LETTER OF TRANSMITTAL	
DATE:	2-13-2002
CONTRACT No.	
PROJECT Name:	SR BURLINGTON
PROJECT NO.:	IM 0209(36)

COPIES	DATE	NO.	DESCRIPTION
1	2/12/02	1	ROW PLANS FOR CONDUIT ACCESS GATES. Sheet 1 to 6 of 6 1- FULL SIZE 1- HALF SIZE

TO: DISTRIBUTION LIST
FROM: Sherward G. Farnsworth, P.E., Project Manager *Sof*
DATE: October 1, 2001
SUBJECT: Semi-Final Plans - South Burlington IM DECK(36) I-89, Exit 14
Relocation of Verizon conduit's and future relocation of Adelphia's conduits from Williston Road bridge over I-89 >>>> Duct Bank Relocation <<<<

PROJECT - BRIDGE NO. 68 SOUTH BURLINGTON U.S. 2 OVER I-93
STATE PROJECT - IM DECK (36)
FEDERAL PROJECT -
CUSTOMER - J A McDONALD
LOCATION - CHITTENDEN COUNTY, VERMONT
DESCRIPTION - EXPANSION JOINT DETAILS WESTBOUND AT PIER 1

TYPICAL FRAME LAYOUT FOR SUPPORT
 1/4" = 1'-0"

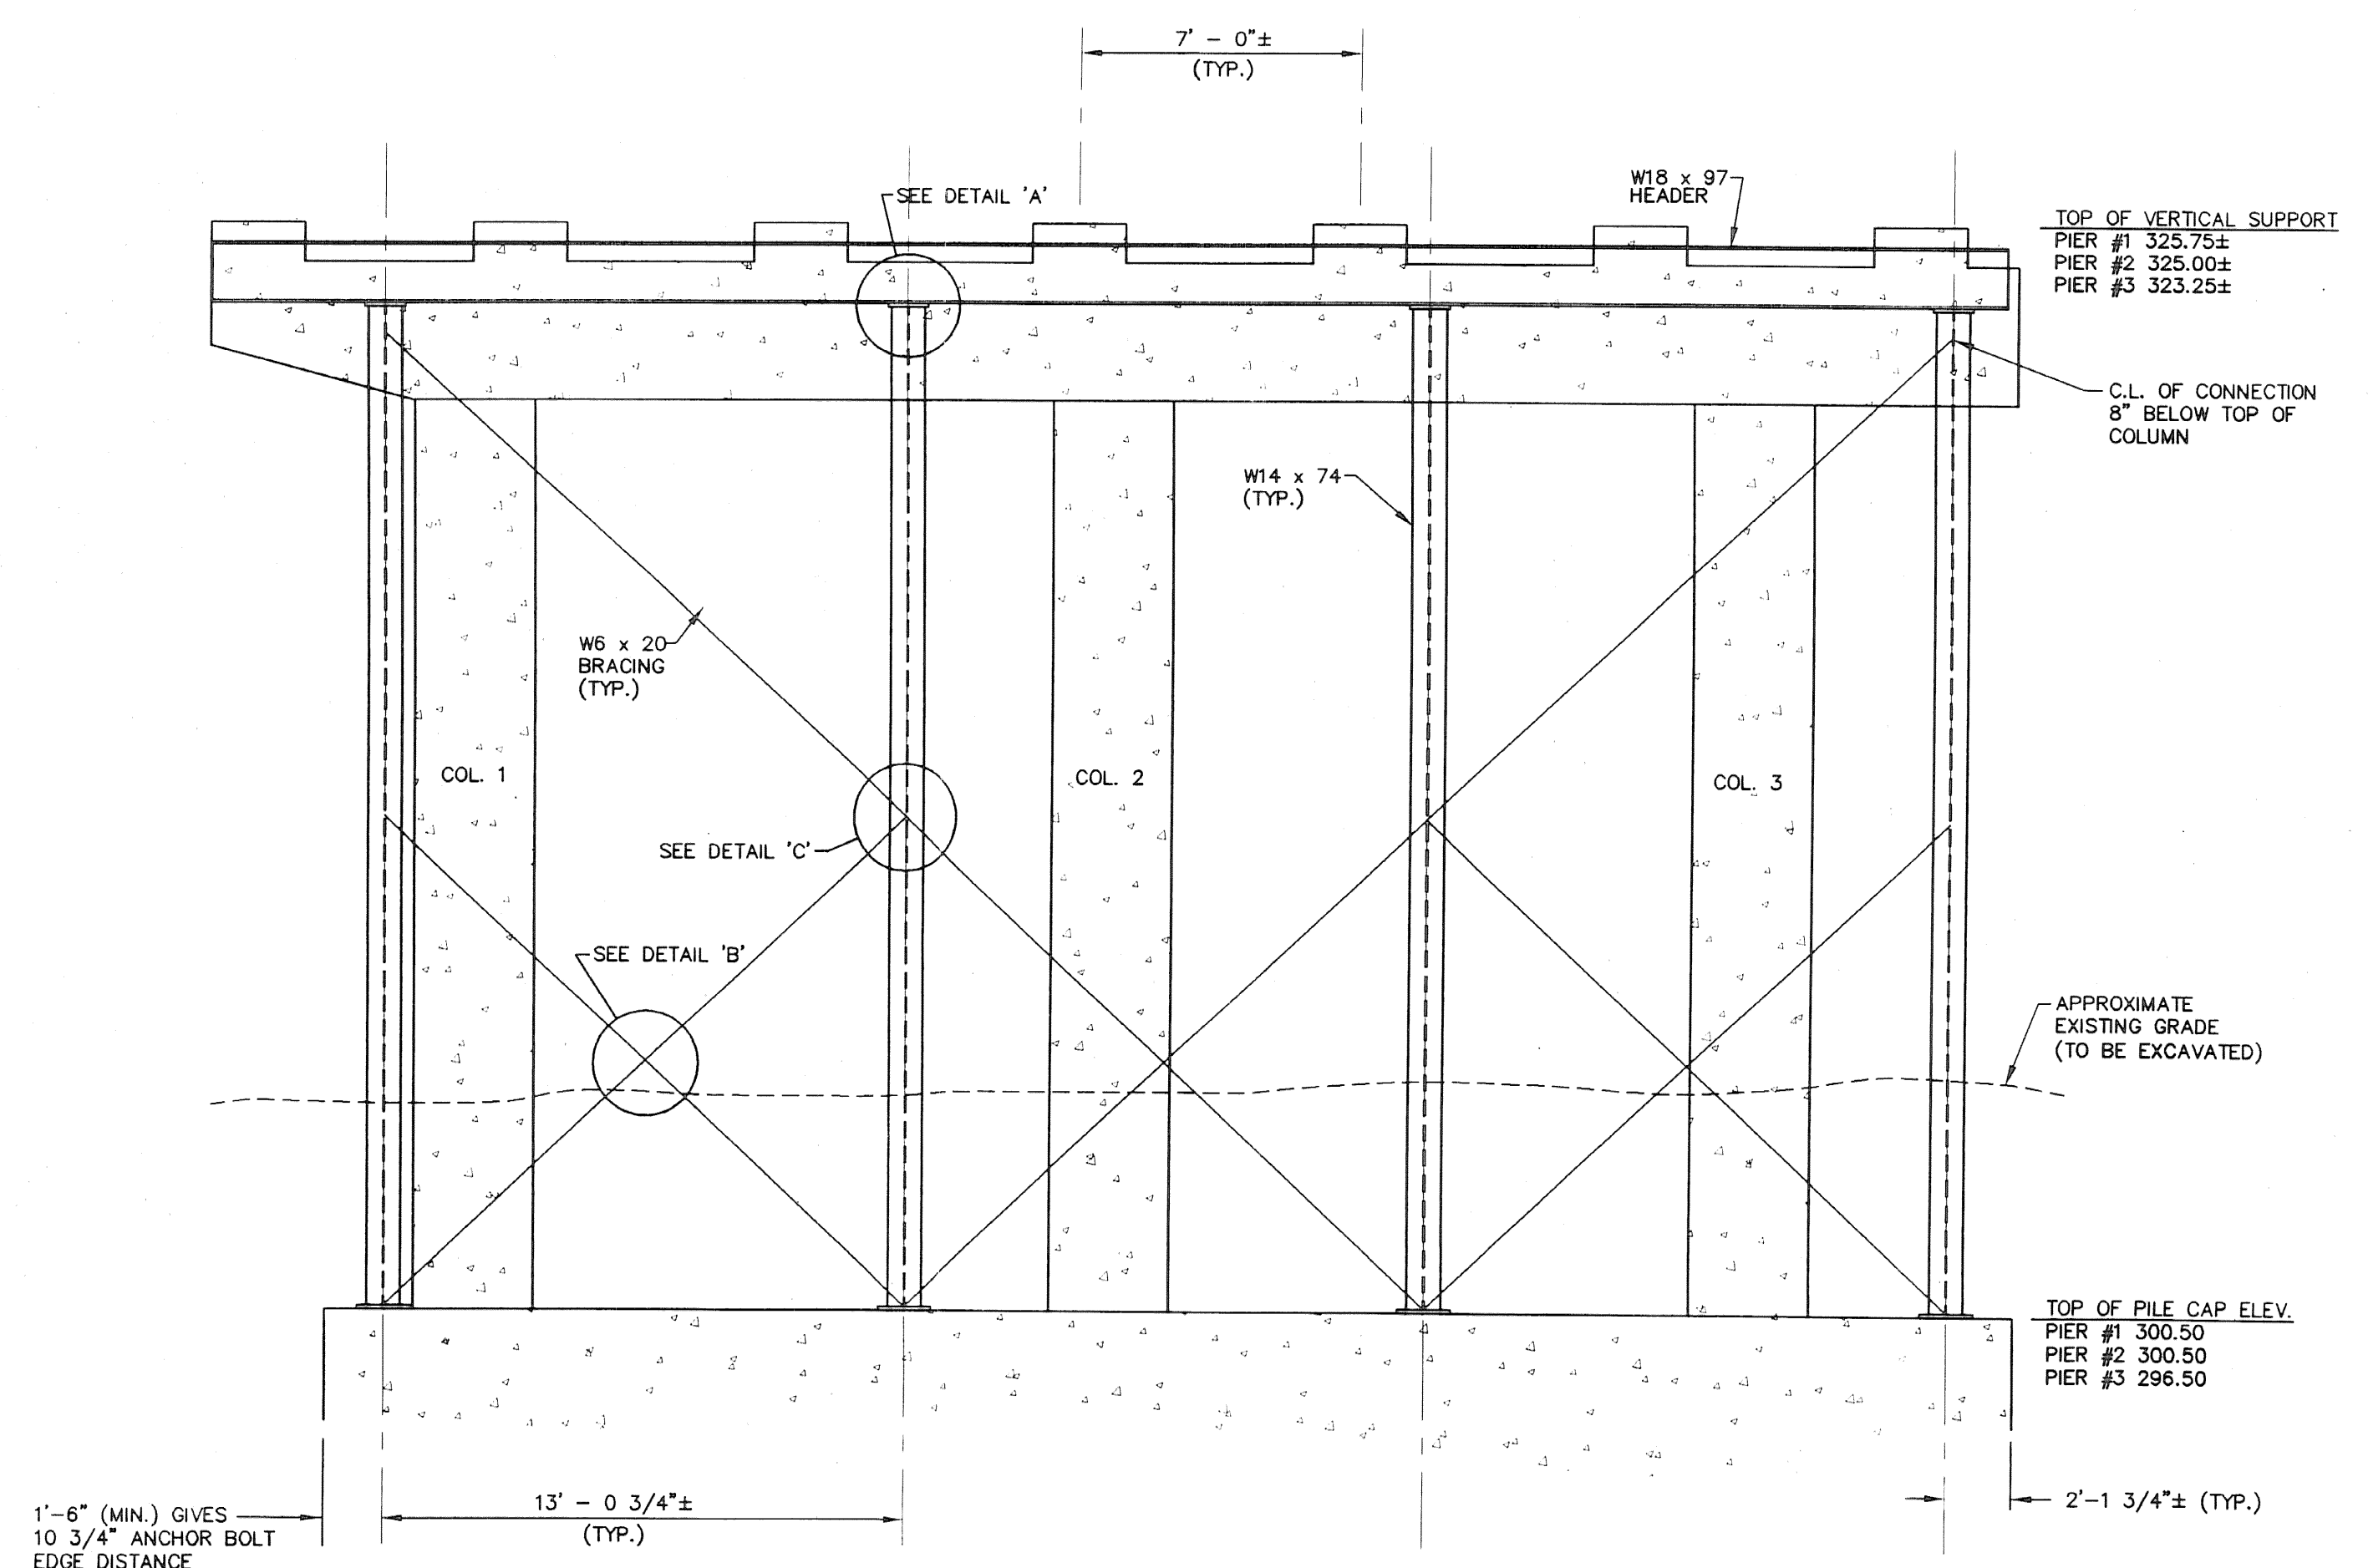
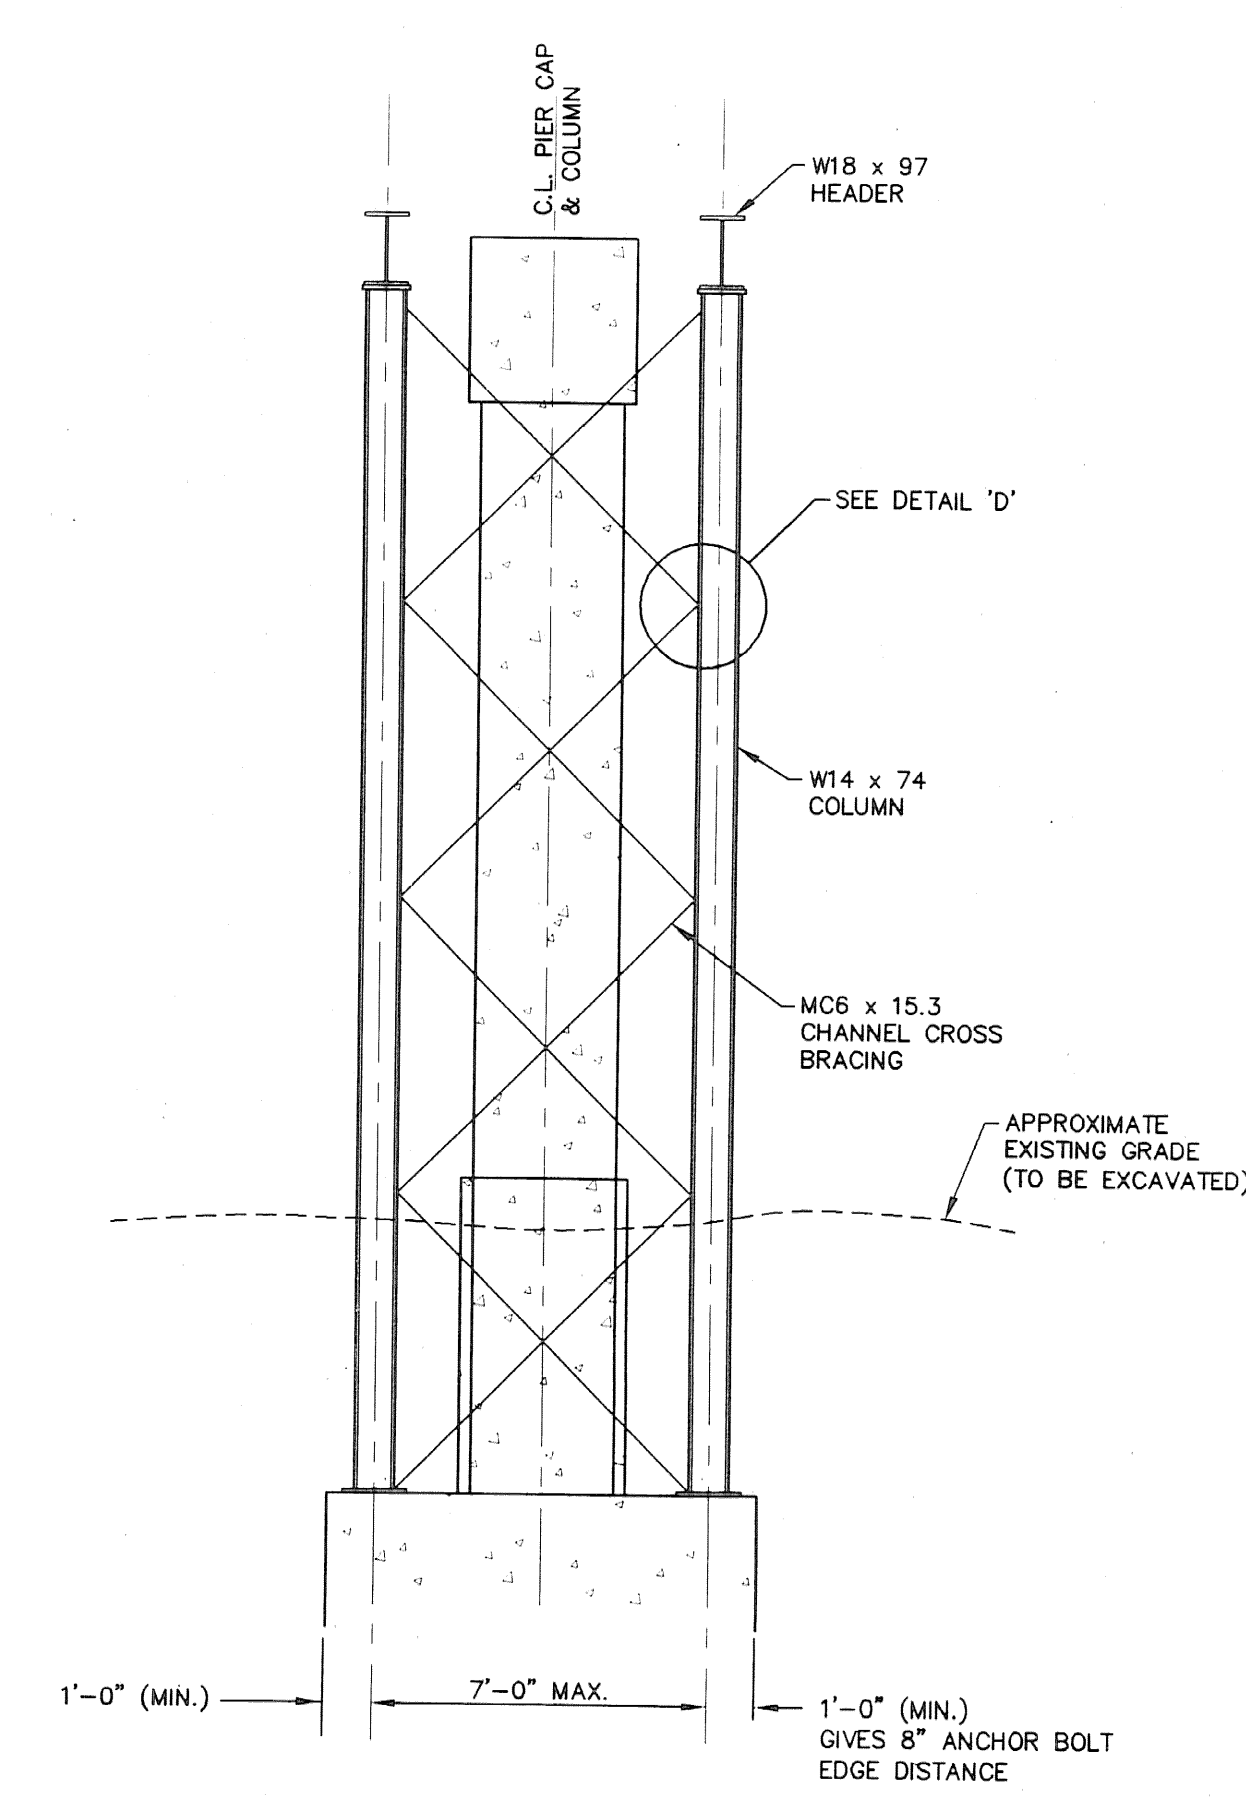
1. One end of each set of stringers will be "fixed" to the beam seat (stub columns) with two heavy duty C-clamps (Proto model 6-HDL shown on attached sheet). Lateral restraint at this "fixed" end will be a 6-inch length of minimum 1/2 inch thick steel welded to the top of the stub column bearing plate adjacent to stringer bottom flange.
2. The "free" end will be restrained against vertical and lateral movement by the detail shown as "E" on our drawing S1 revised June 27, 2000.

①* - DENOTES SPECIAL WING WALL POST SEE SECTION "N" PAGE 2/2
 VERIFIED BY FIELD MEASUREMENTS 9/25/00

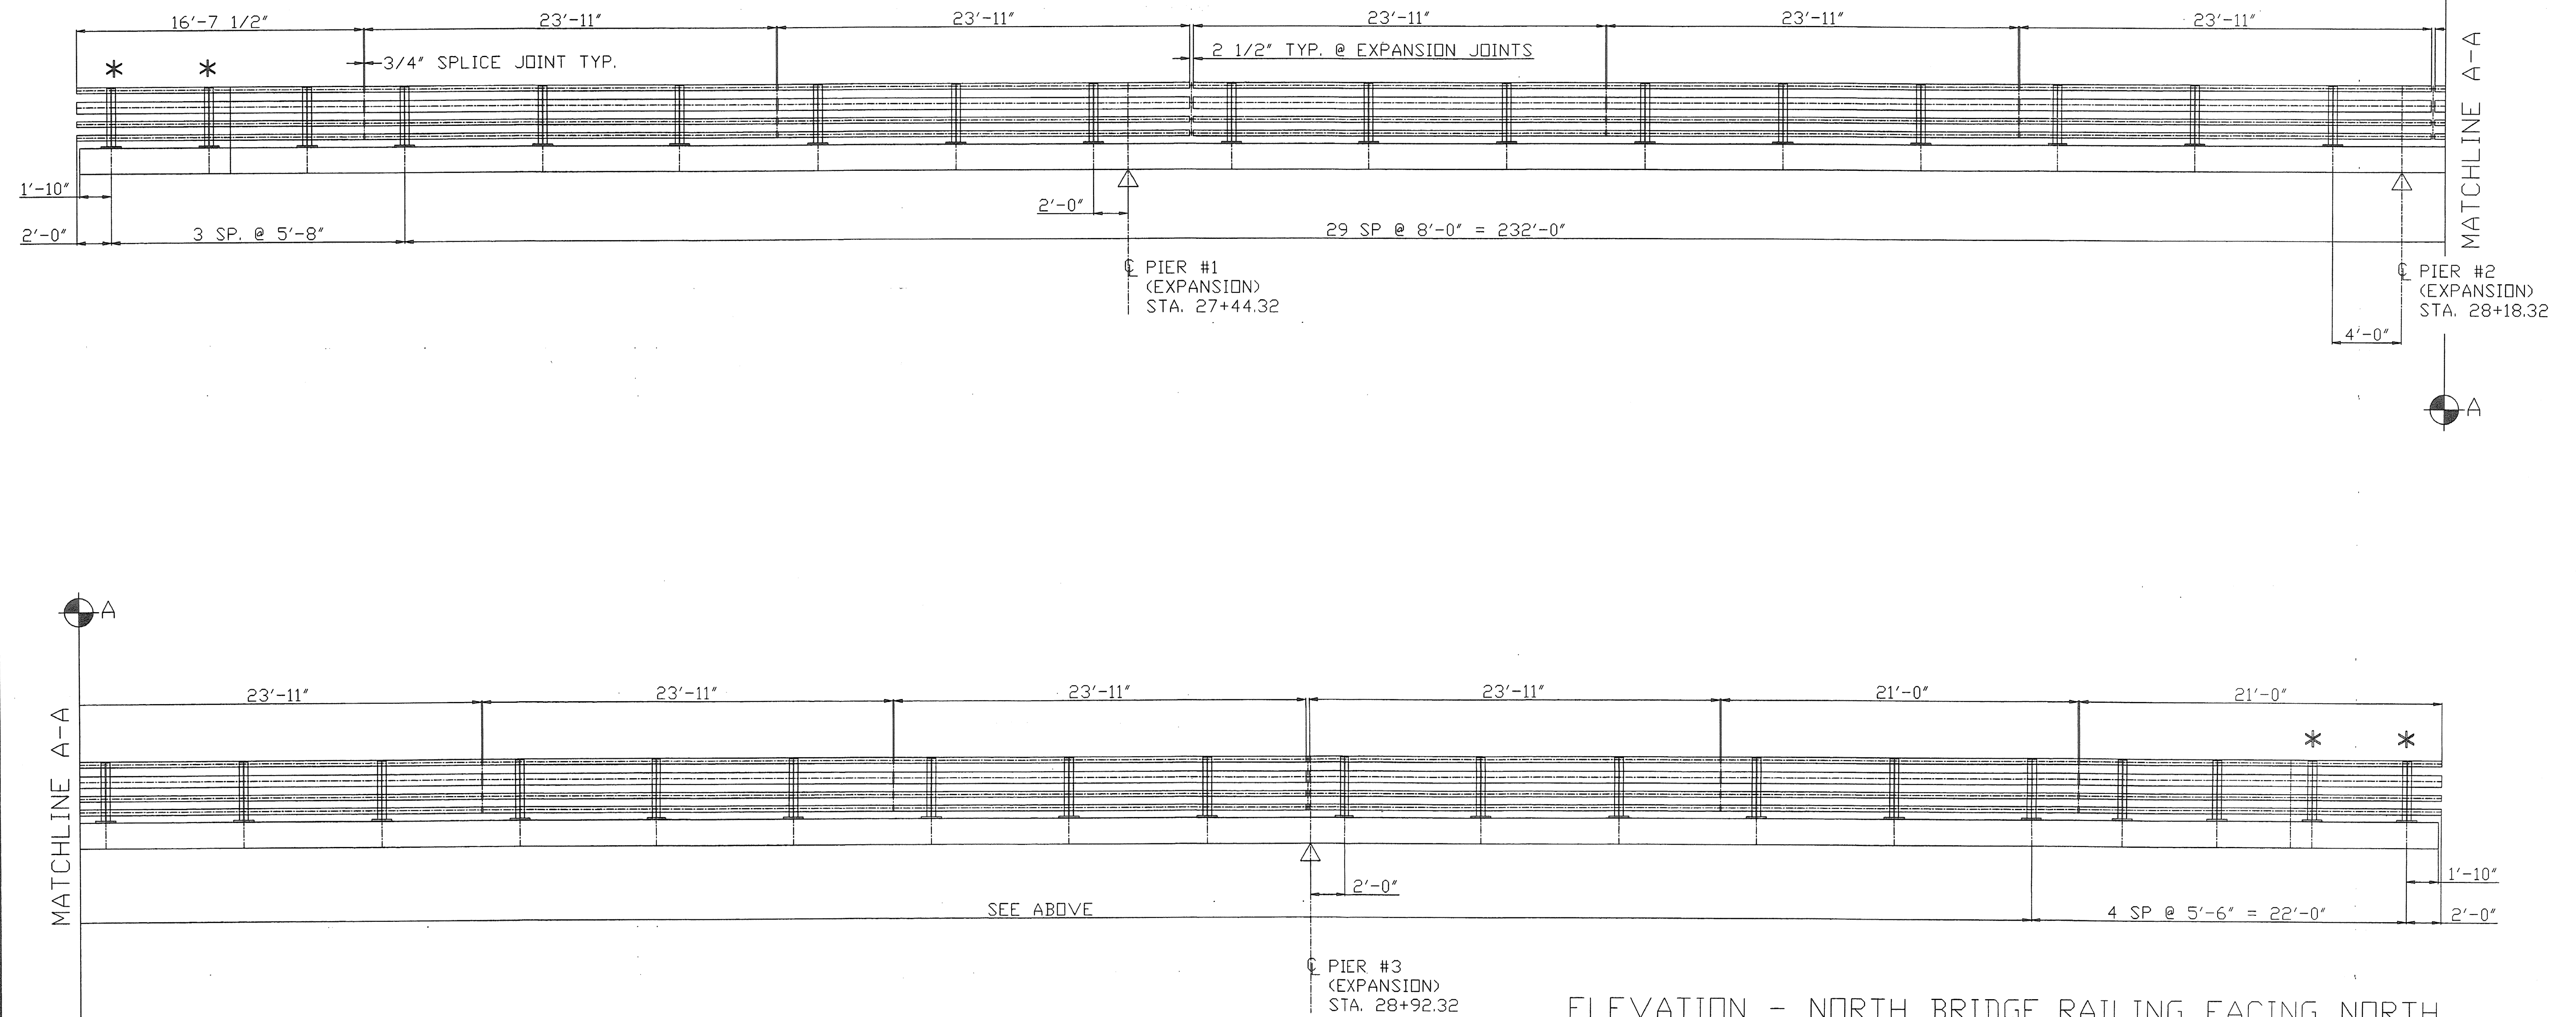
- The proposed bridge rail layout and approach rail layout has been field verified as shown on sheet 26 of the contract plans.
- The configuration of the offset block has been determined from contractor's field measurements. (OK - noted on plans)
- The post locations on the wingwalls meet the minimum requirements as shown on Detail A-Sheet 26 of 75.
